Access Compliance Report Public Rights-of-Way (Pedestrian Signals)

Main Street: ORTEGA_HWY Cross Street: ORTEGA_HWY Location: SW

ADA ID: SGRK211118141451 Signal Type: One Push Button-Non APS Overall Compliance: No Severity Scores: BTN 1: 35 BTN 2: N/A No BTN: N/A

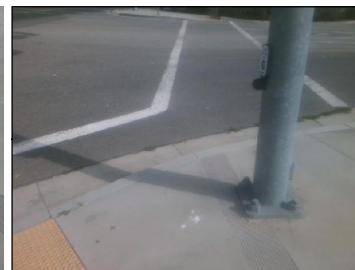
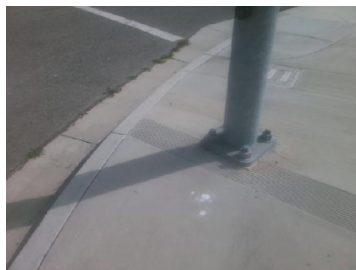
OC Std/PROW: R404.2, MUTCD 4e.08

Possible Solutions: Replace Signal Push Button With APS Button. Remove and Replace Clear Space.
